UNITED STATES PATENT AND TRADEMARK OFFICE

Office Action Summary

10/729,366

SAGOL, SAMI

A H schment A

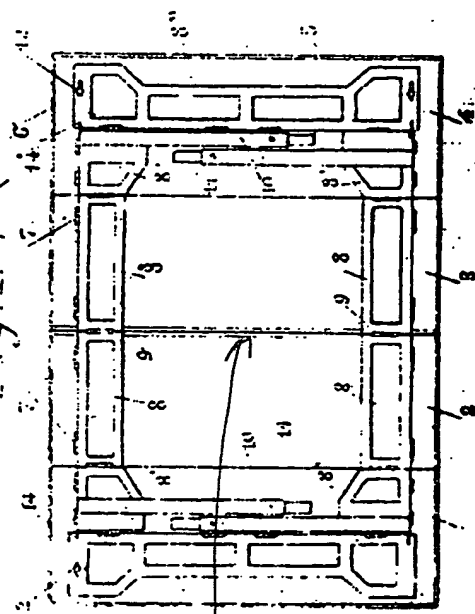
Claims 1, 3, 5, 10-12, 21, 23 and 30 are rejected under 35 U.S.C. 102(b) as being anticipated by French patent 738,868. The French reference teaches a collapsible table (Figs. 1-3; see Attachment A) comprising a table top formed of a pair of pivotable

table top half-sections (1/2 and 3/4) hinged to one another at their adjacent edges along a center-line of the table and displaceable between an open position where said half-sections are coplanar and a folded position where said half-sections overlap one another; the table characterized in that each section has at an undersurface thereof a transverse support member (8 both portions) pivotally articulated thereto with a leg (10) associated with each lateral edge of each transverse support member, and a pair of longitudinal support members (8) pivotally articulated to the undersurface; said support members are displaceable between erect and collapsed positions whereby the transverse support members are prohibited from collapsing as long as at least one of the longitudinal support members is erect. The half sections further include abutment surfaces (adjacent touching edges formed at the hinge line of the table top) and a skirt (6).
